RECORD OF DECISION AMENDMENT

**NORTH PENN AREA 5
SUPERFUND SITE
Operable Unit 1
Montgomery County, Pennsylvania**

**U.S. ENVIRONMENTAL PROTECTION AGENCY
REGION III, PHILADELPHIA, PENNSYLVANIA
July 2016**

RS Figure 1. 1,1-DCE and TCE Concentrations Trends at PW-9B

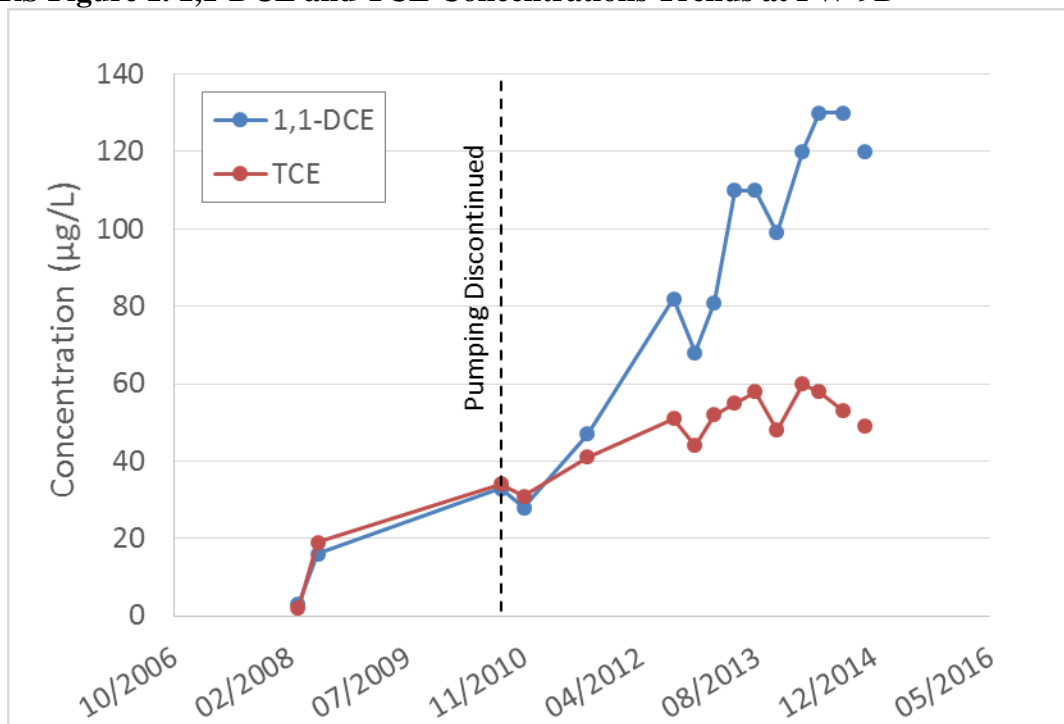
3.1.5 EA Comment 5: “The mass removal rate of the former pump and treat system was already maximized and demonstrates the limited effectiveness of this remedial option.”

EPA Response: BAE’s historic pumping has not been operational since August 2010 and, prior to that time, was not optimally designed for mass removal and source control. Hydraulic testing conducted by Environmental Alliance during the PDI demonstrated that some of the most contaminated wells at OU1 had a weak hydraulic connection with the extraction wells associated with historic pumping. For example, as part of the PDI, wells RW-1 and the Recovery Well were re-started in March 2008, but showed little or no hydraulic response in well PW-10A.

In contrast to well MW-5, contaminant concentrations at PW-9B increased when groundwater pumping was discontinued in 2010. RS Figure 1 (below) shows the TCE and 1,1-DCE concentrations at PW-9B from February 2008 until December 2014. When pumping was discontinued, concentrations of TCE and 1,1-DCE increased at PW-9B, which suggests that groundwater extraction, if effectively designed, can reduce plume concentrations and facilitate restoration of the aquifer. It is not clear, based on the available data, which extraction well most impacted the concentrations at PW-9B, but the system restart test suggests that, of the three extraction wells, RI-20S likely has the strongest hydraulic connection with PW-9B. RI-20S generally operated at less than 1 gallon per minute (gpm) from 2004 through September 2009 and only increased to an average of 3 gpm in 2010 before being shut down in August 2010. PW-9B was first sampled in 2008 and sampling was limited between 2008 and 2010.

MW-5, RI-20S, PW-10A and other wells continue to have elevated concentrations of TCE and 1,1-DCE. As shown in RS Figure 1 (above), concentrations at PW-9B have increased since 2010, suggesting that pumping had reduced concentrations at that area. Unfortunately, PW-9B and other recently installed bedrock monitoring wells were not installed earlier, which, through sampling, would have allowed for the identification of concentrations trends during pumping.

Since historic pumping was discontinued in 2010, contaminant trends do not indicate that groundwater will decrease to MCLs. Please refer to RS Figure 1, above, which shows a clear trend of increasing concentrations at well PW-9B. At wells MW-5 and PW-10A, concentrations have varied during the monitoring period, but overall have remained about the same since 2003 and 2008, respectively.
